City of Surrey
PLANNING & DEVELOPMENT REPORT

File: 7915-0035-00

Planning Report Date: October 3, 2016

LOCATION: 6388 King George Boulevard

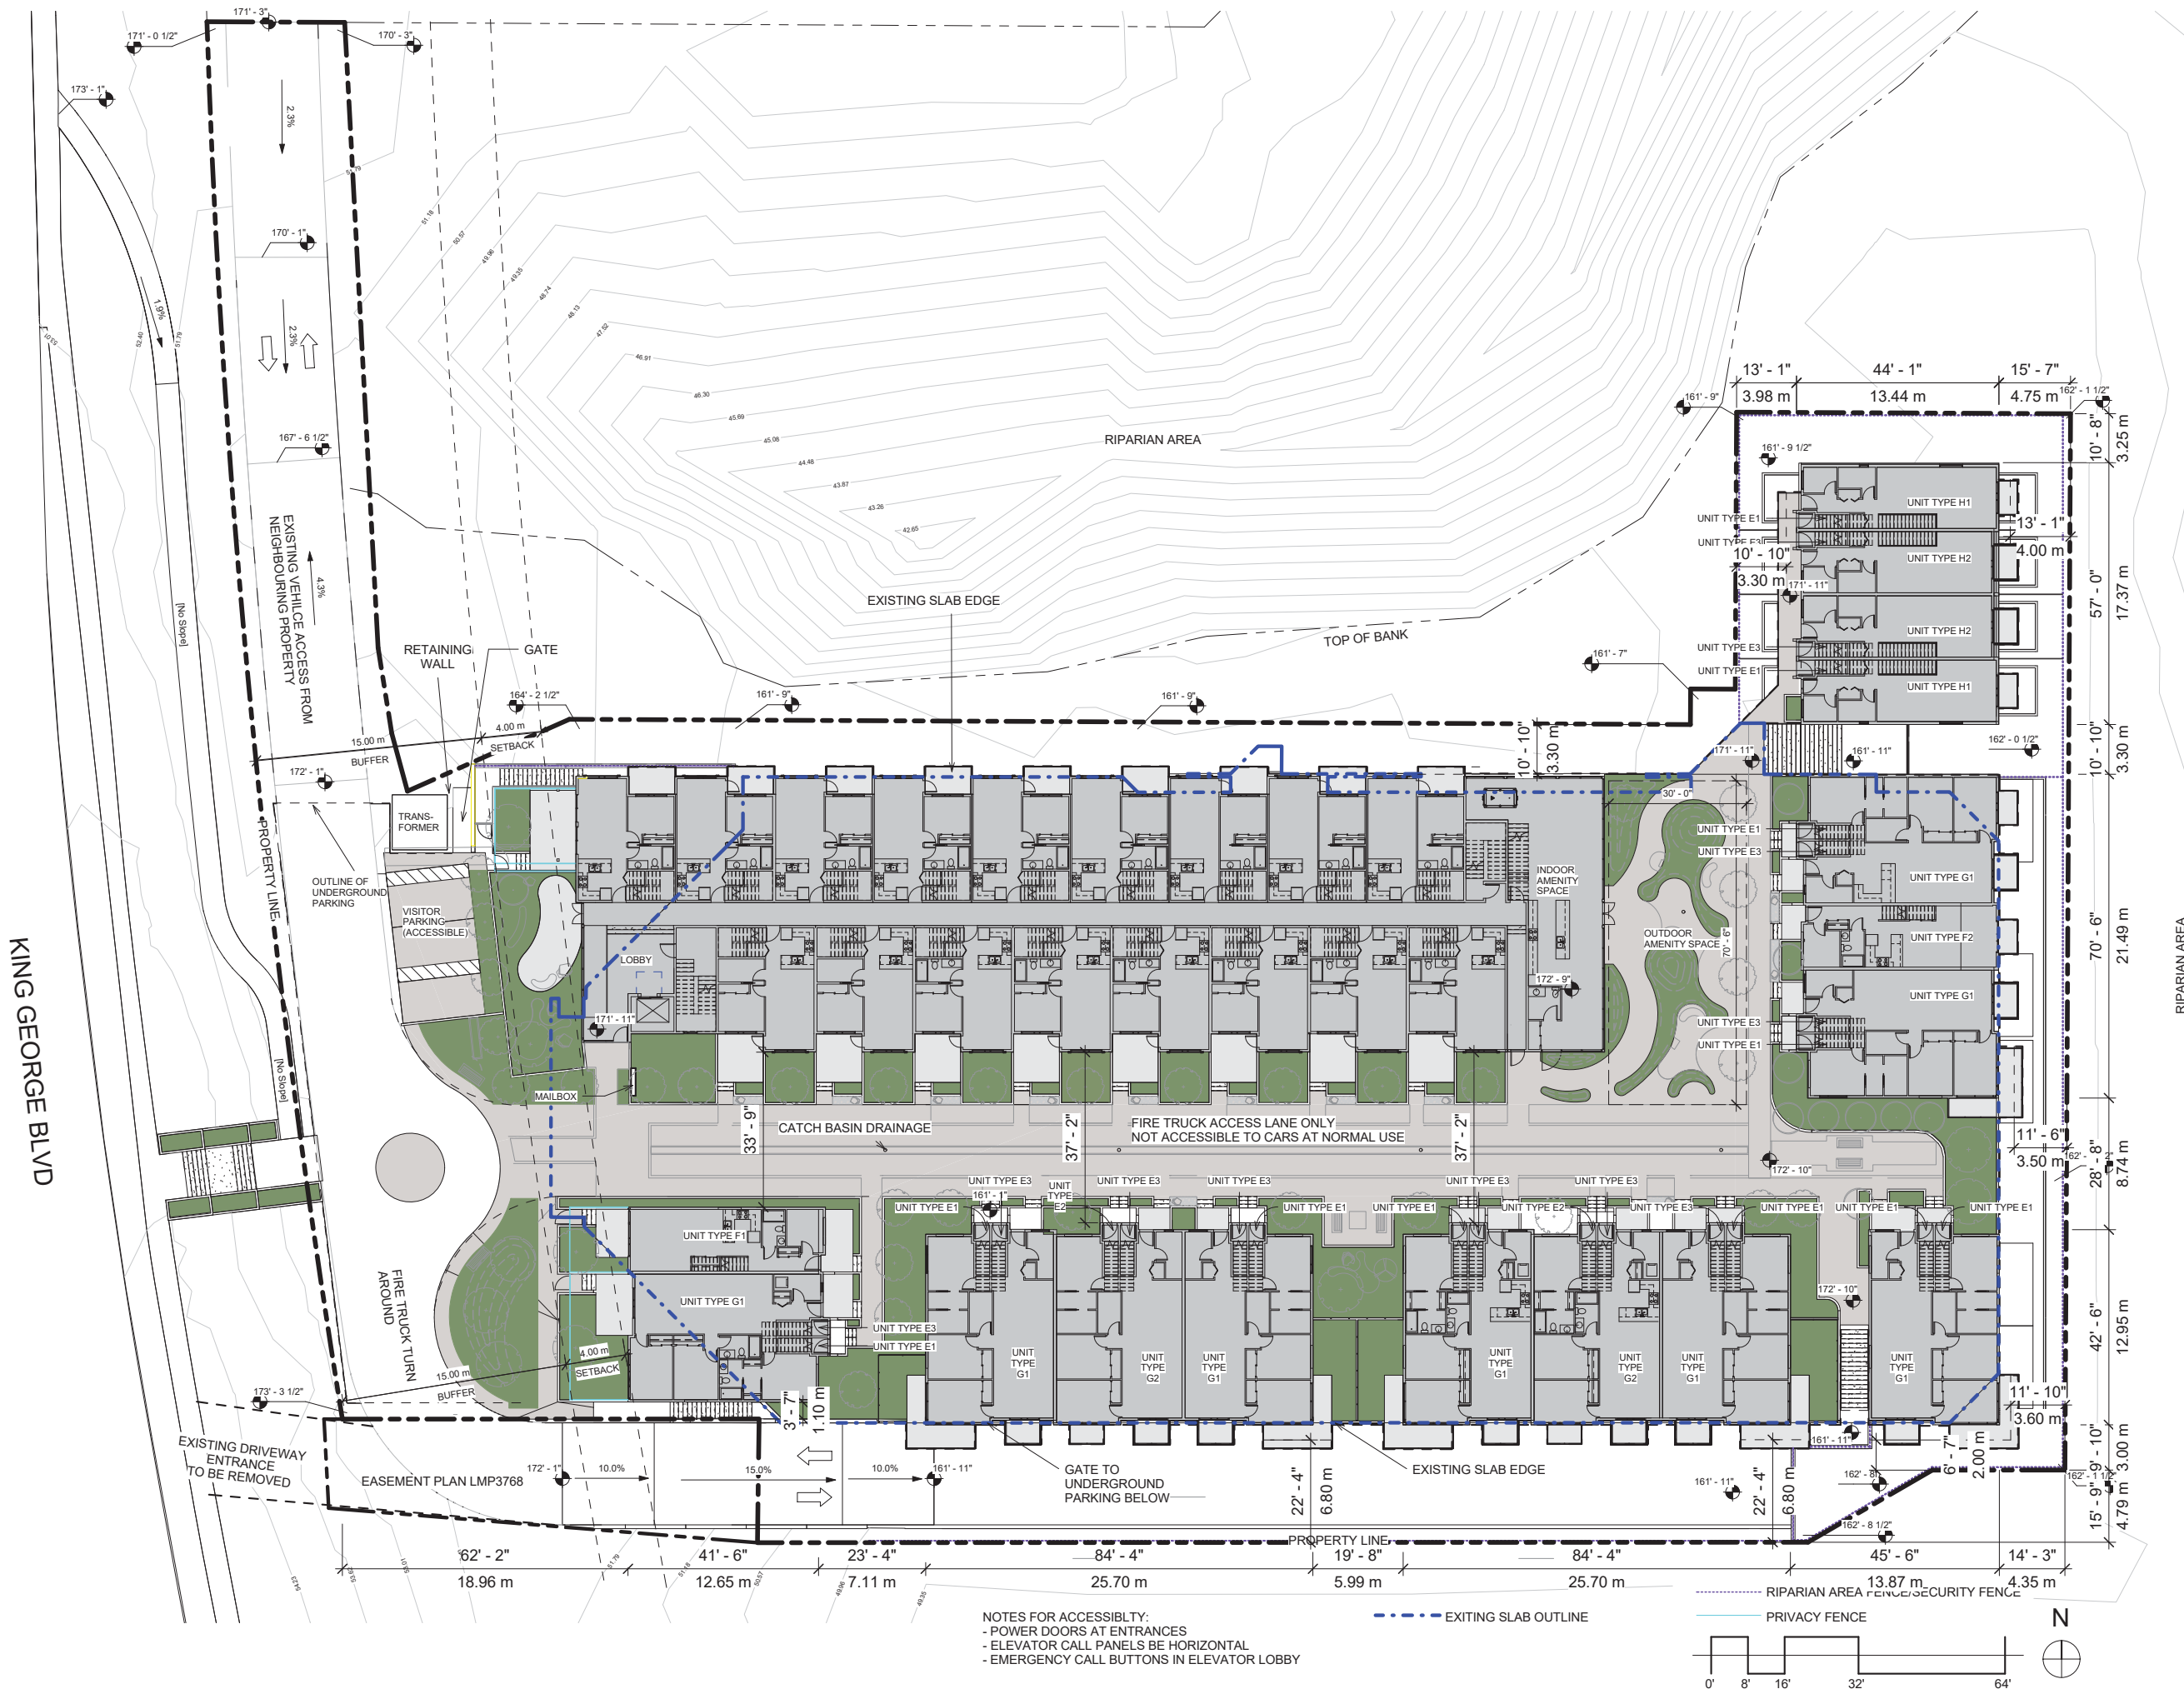
- Recommend power doors at entrances.
Will be included; Note added to plans (Please refer to A200/A201/A210)
- Recommend elevator call panels be horizontal.
Will be included; Note added to plans (Please refer to A200/A201/A210)

- Recommend emergency call buttons in elevator lobby.
Will be included; Note added to plans (Please refer to A200/A201/A210)
- Recommend wheelchair accessible washroom in indoor amenity space.
Washroom has been added (Please refer to A210)

NOTES FOR ACCESSIBILITY:
- POWER DOORS AT ENTRANCES
- ELEVATOR CALL PANELS BE HORIZONTAL
- EMERGENCY CALL BUTTONS IN ELEVATOR LOBBY

DRAWING TITLE:
SITE PLAN

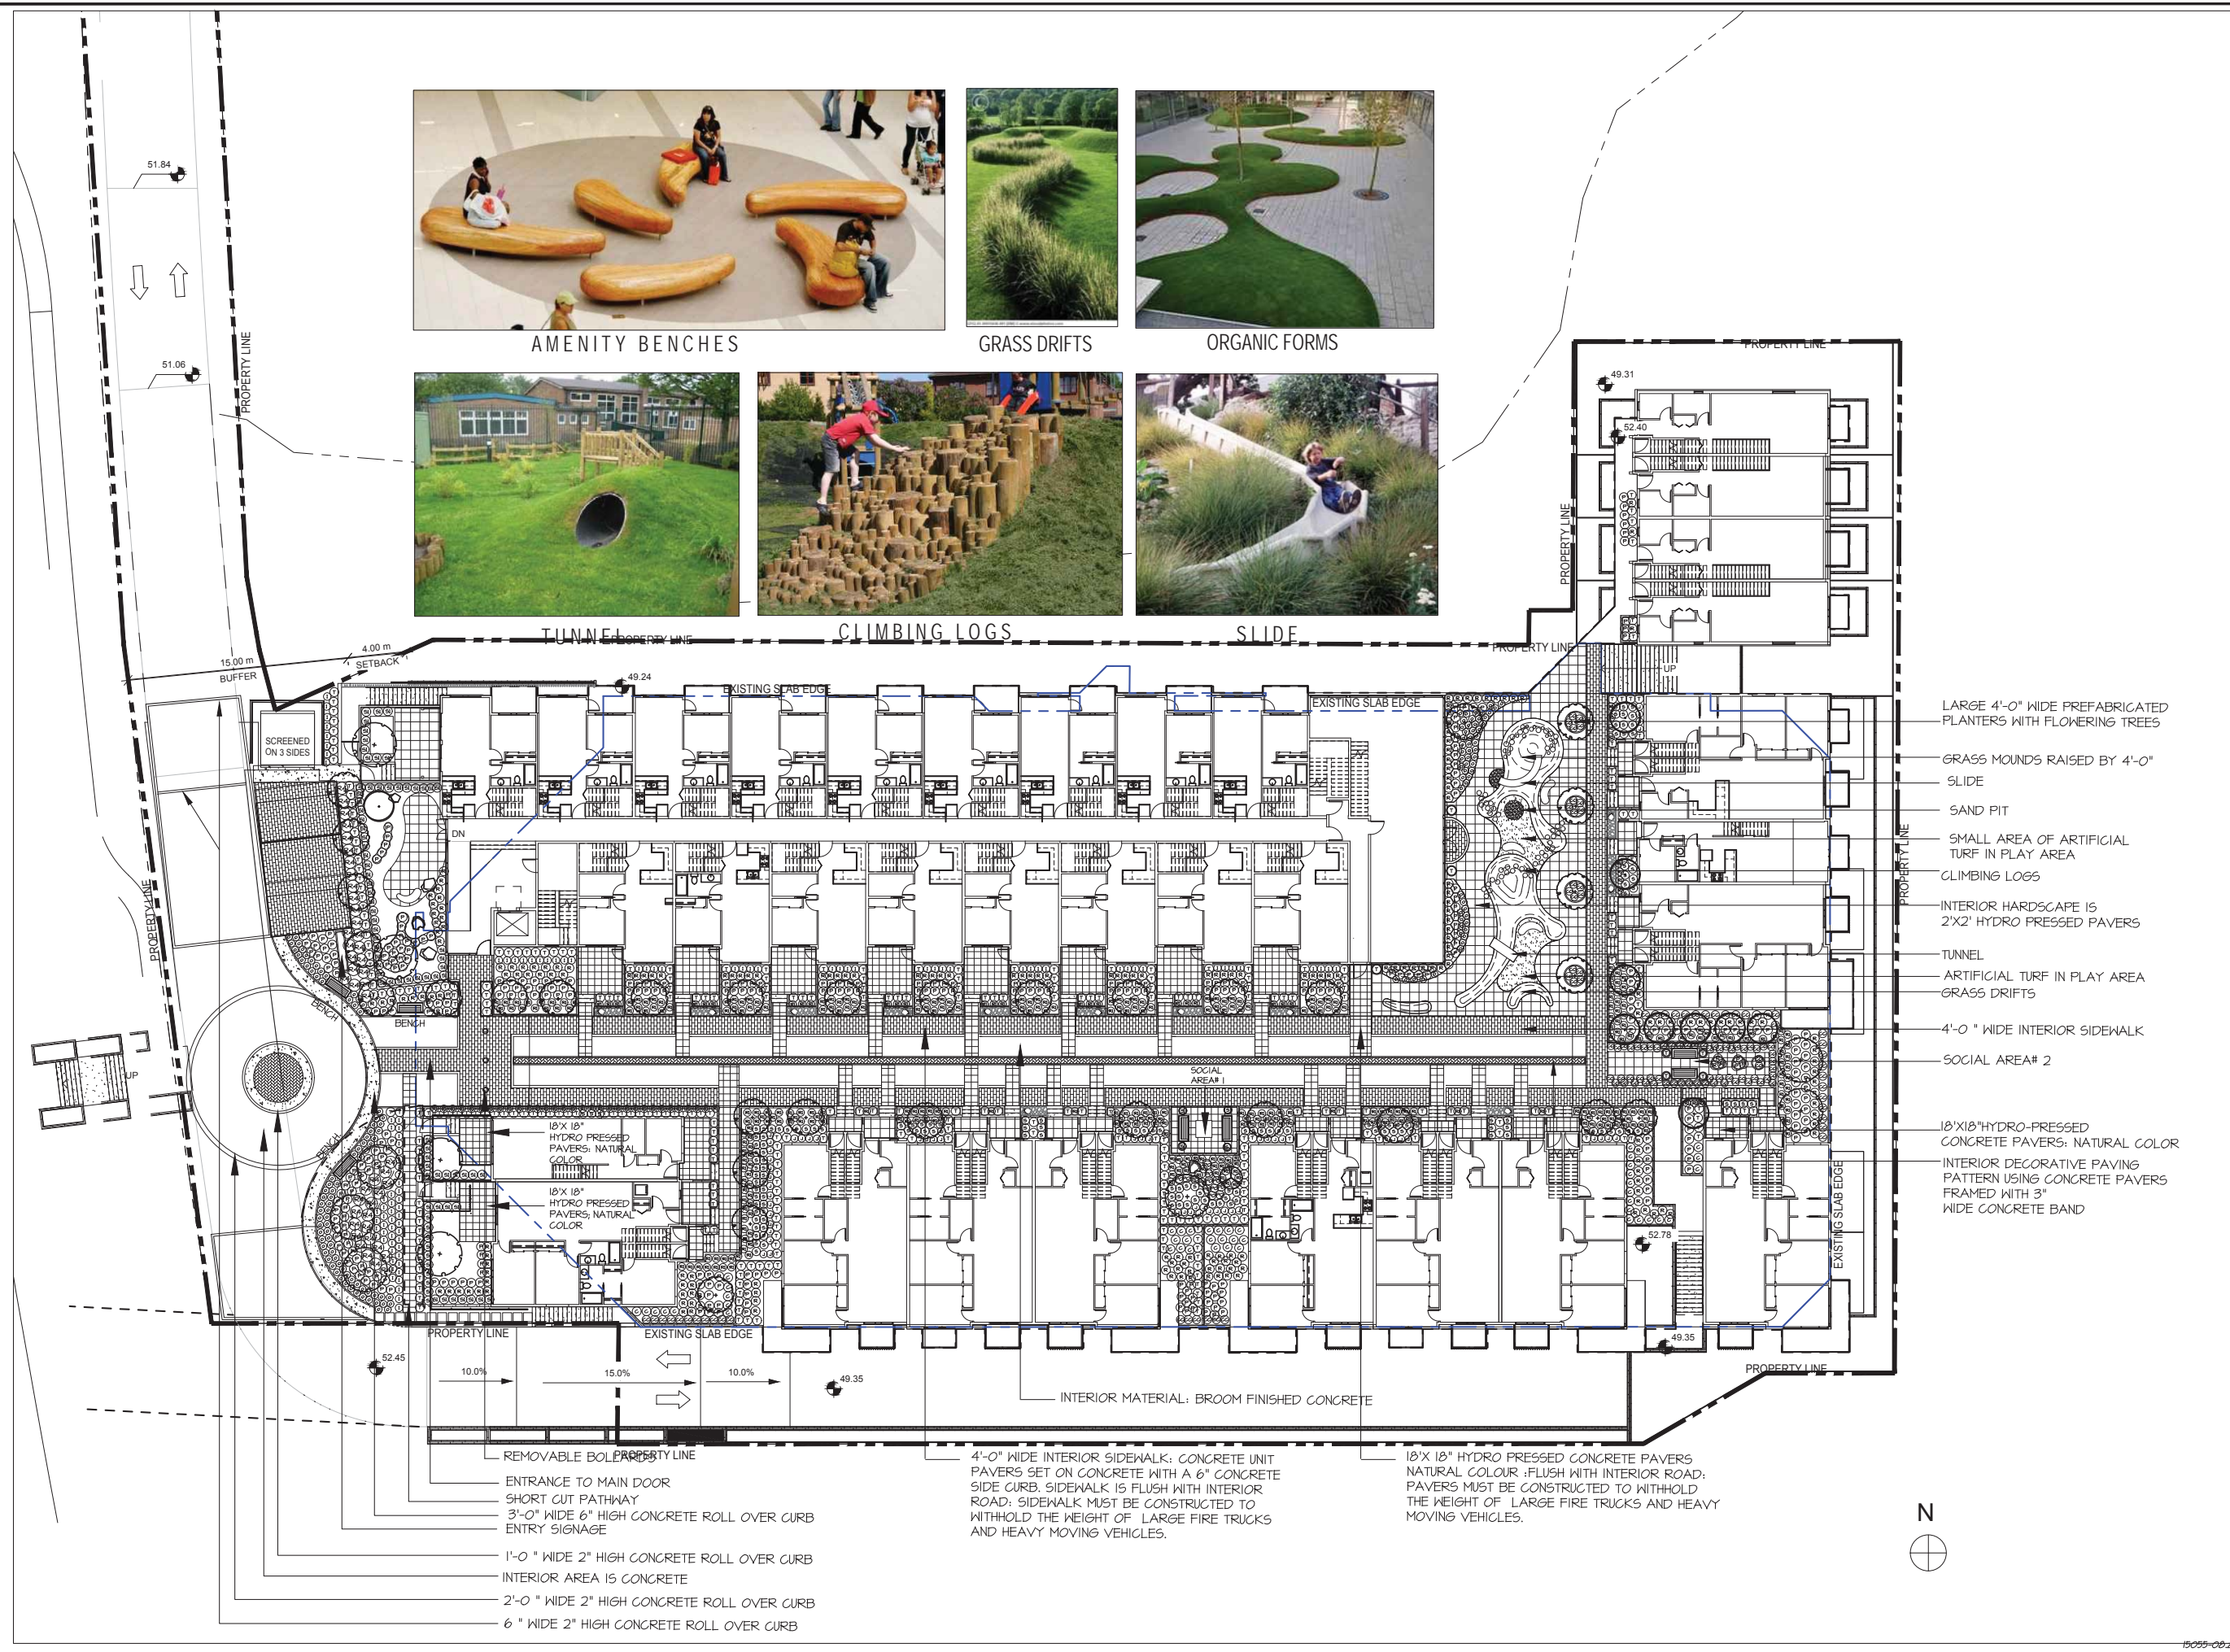
- While the change to the site plan by flipping the townhouse/apartment blocks was commended, the landscape design and treatment of the fire access needed significant design development.

Landscape design has been revised significantly (Please refer to L1 and A200)
